**CITY OF CORCORAN
Corcoran Planning
Commission Agenda
June 1, 2023 - 7:00 pm**

Planning Commission Meeting: June 1, 2023	Prepared By: Natalie Davis McKeown
Topic: Red Barn Pet Retreat Comprehensive Plan Amendment, Rezoning, Preliminary Plat, Conditional Use Permit, and Site Plan (PID 01-119-23-44-0045) (City File No. 23-008)	Action Required: Recommendation

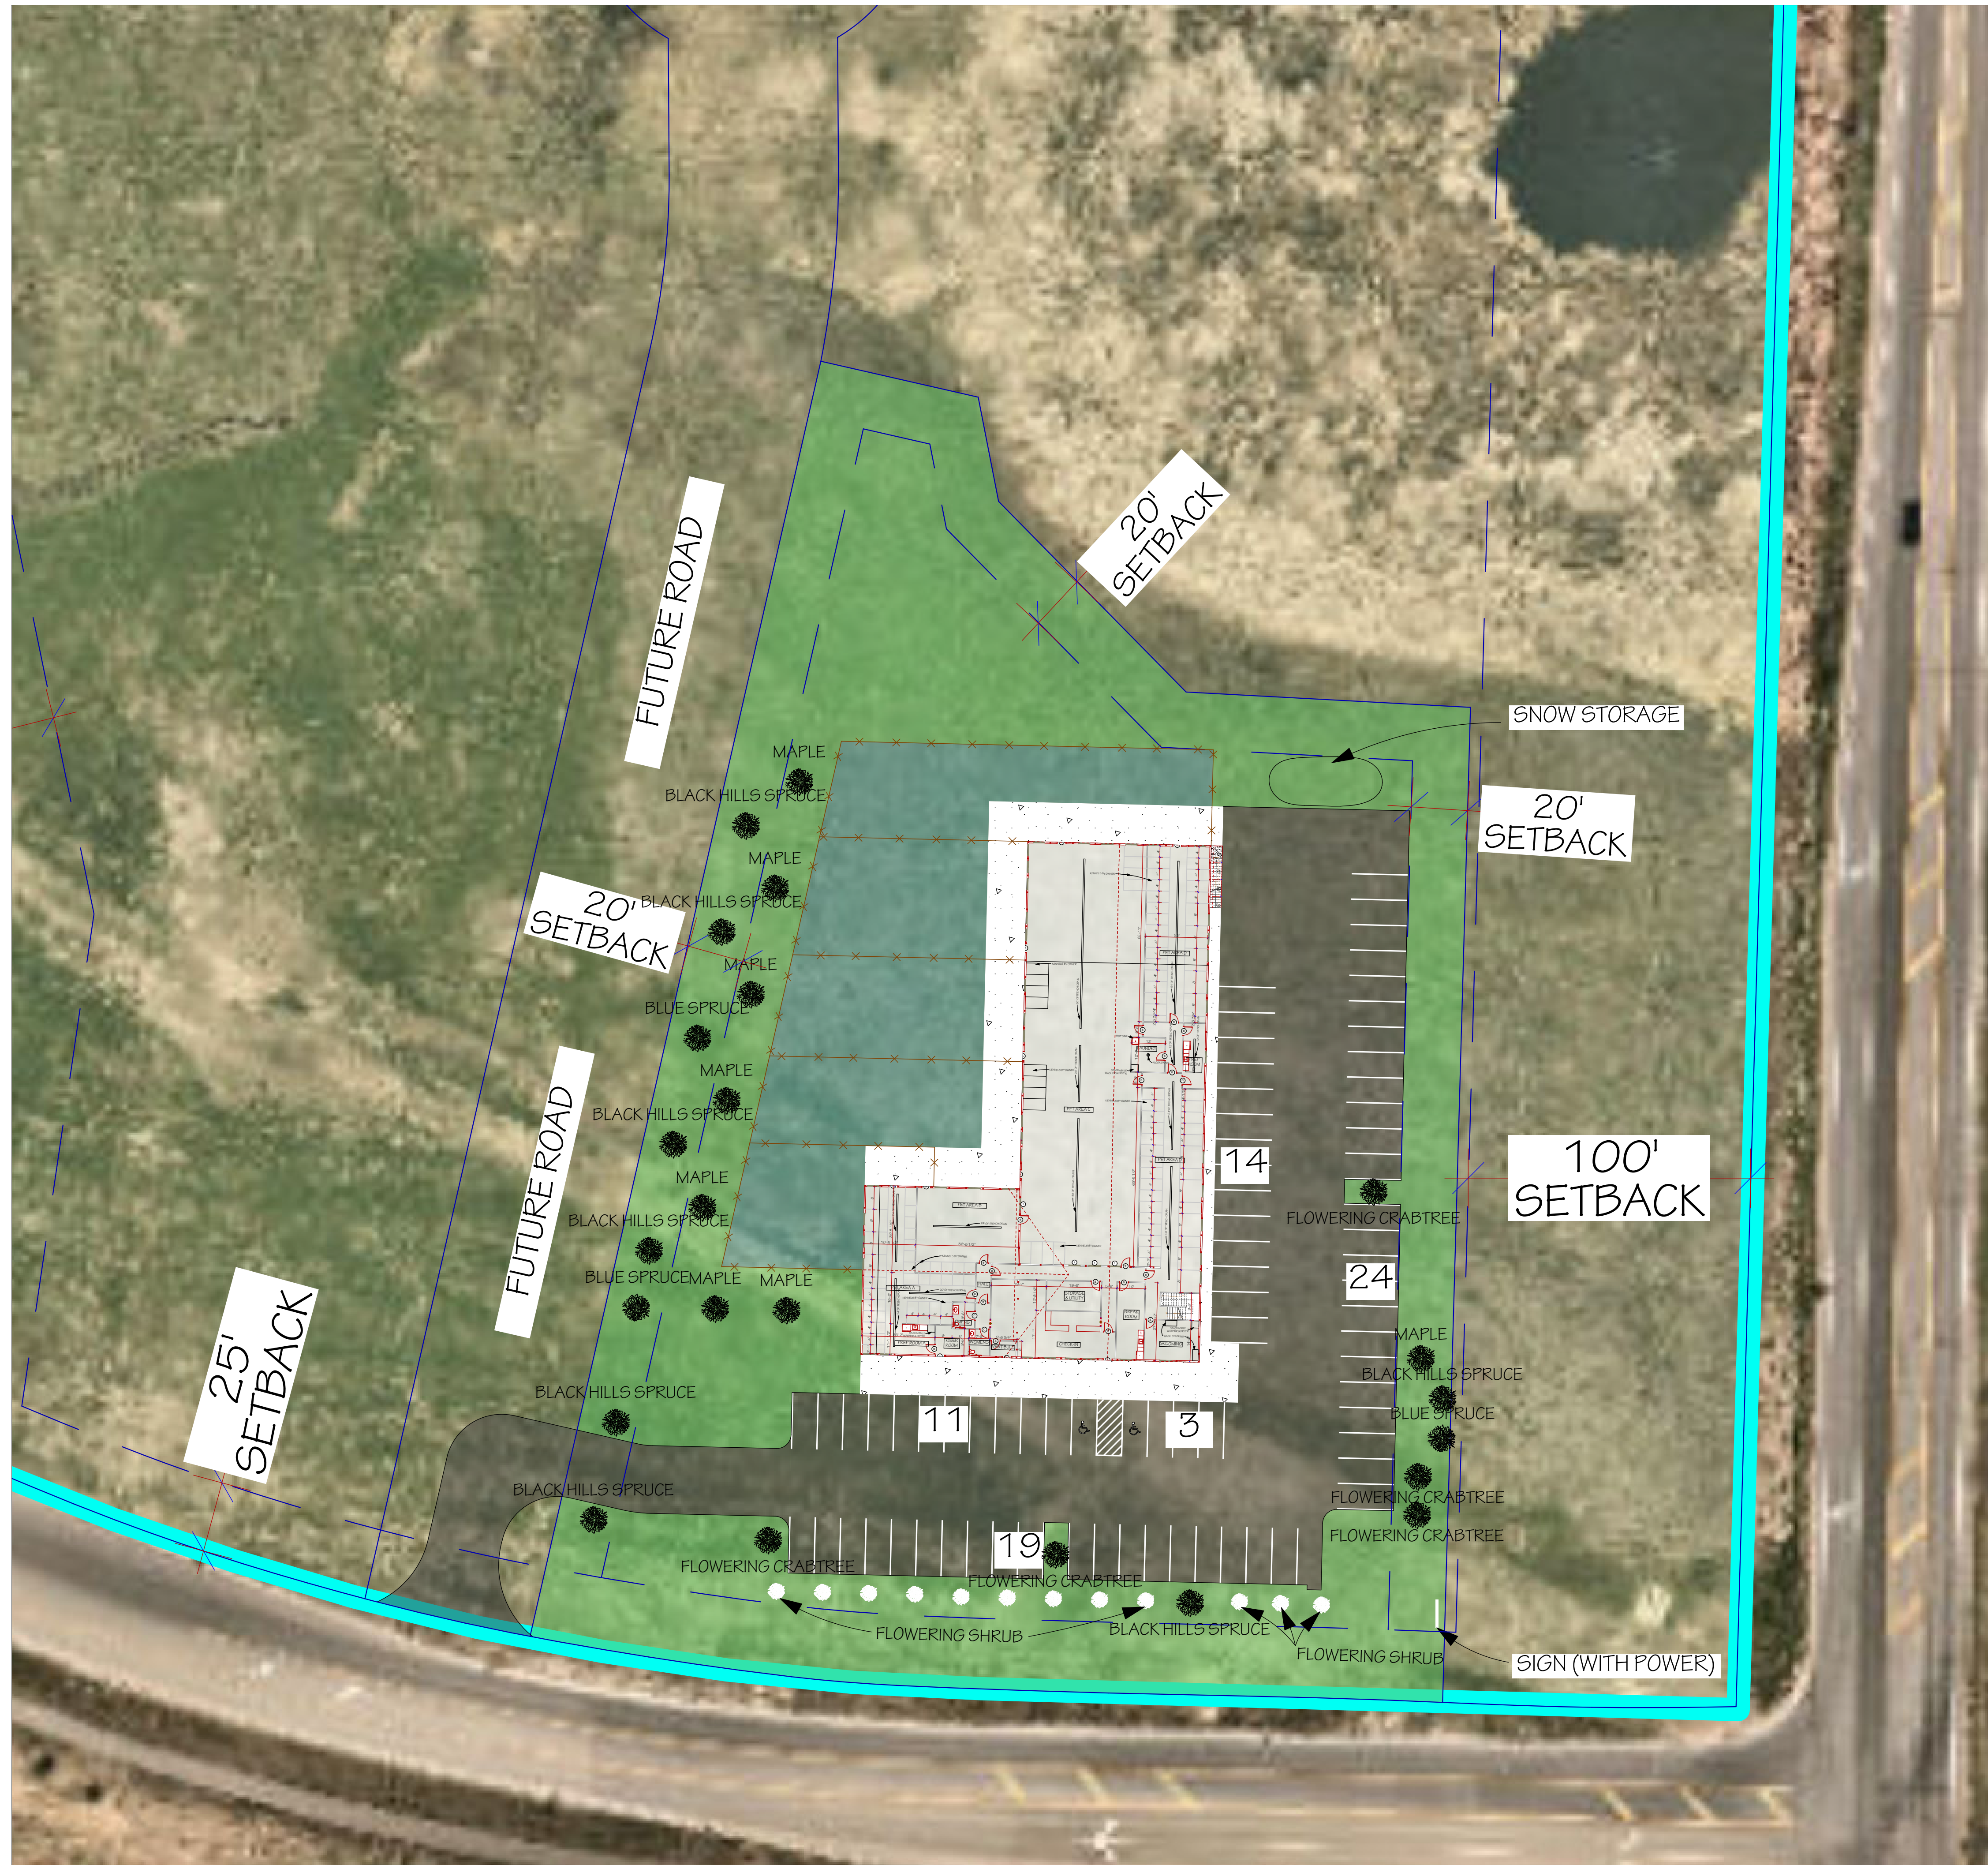
The applicant's site layout plan shows 74 striped parking stalls including 2 handicapped spaces. The most similar use contemplated in the Subd. 8 table appears to be "office buildings, animal clinics, medical/dental clinics." This requires one parking space for each 200 square feet of floor area with a minimum of 8 spaces required. Under this formula, a minimum of 88 parking spaces are required. Considering the drop-off nature of the facility, this number may be excessive to accommodate employees and peak hours of use.

The parking lot is designed with 90-degree parking throughout. Accordingly, each parking stall must have a minimum width of 9', length of 18'6", depth of 18'6", and an aisle width of 26'. The parking stalls comply or exceed these dimensions, but the drive aisle on the site layout is 24'. A foot can be gained on both sides of the drive aisle if the stall length and depth is reduced from 20' to 19'. This would still exceed the length and depths standards in code while achieving the required drive aisle dimension. The plans must be revised accordingly as a condition of approval.

During the review, staff noted the parking lot in the site layout does not match up with the parking lot shown in the landscaping plan do not quite line up, particularly near the northeast end of the building. The plans must be revised to be consistent throughout.

2 NORTH ELEVATION
A4 SCALE: 1/8" = 1'-0"

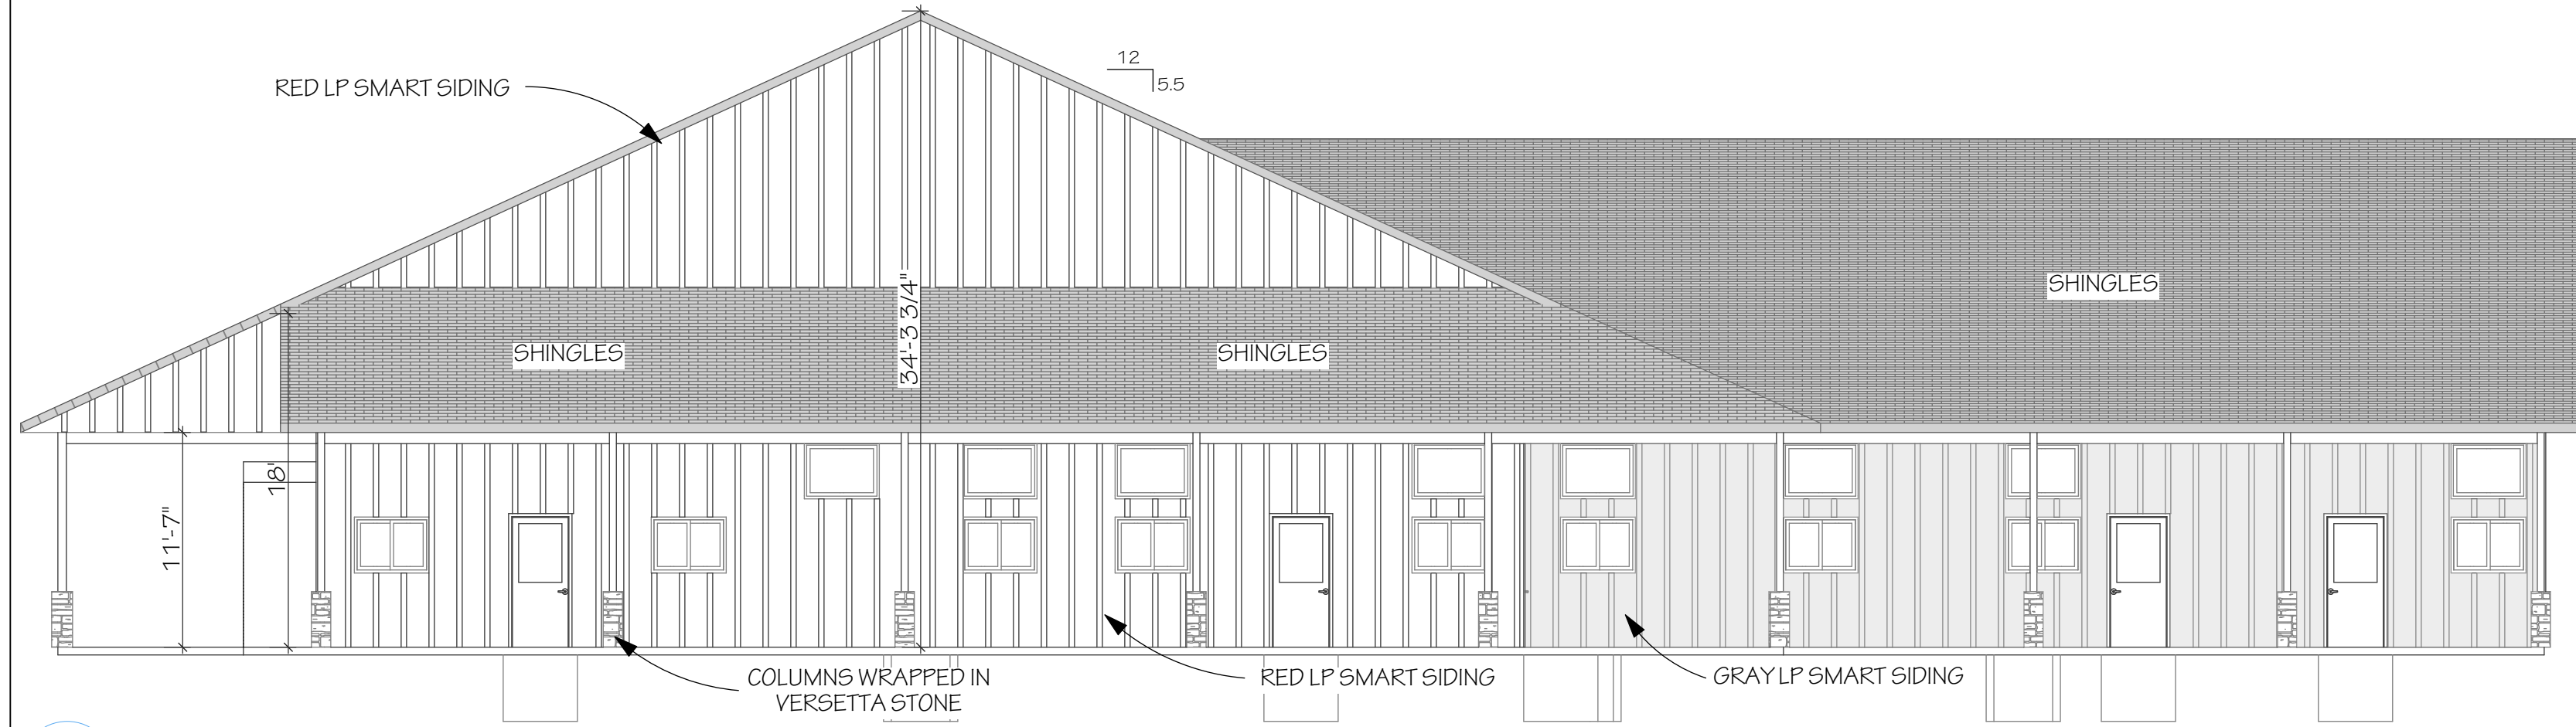
The plans state that the east elevation includes a combination of LP Smart Siding and 13% versetta stone. However, the use of versetta stone on this elevation doesn't seem accurate. The middle of the building shows wooden shakes with a mural. Wooden shakes do not appear to be a pre-approved material in any of the classes. However, this could be approved by the Council as a material of similar quality. If the shakes make up 13% of the east elevation as suggested by the plans, then it would need to be approved as a similar quality material as compared to the materials identified in either Class I or Class II. Staff believes Class II could make sense. Assuming the Council approves the use of LP Smart Siding and wooden shake for this site, then the building materials comply with the NE District standards with a condition of approval added in the draft resolution that the stone veneer comply with the thickness standard of at least 5/8 inches.
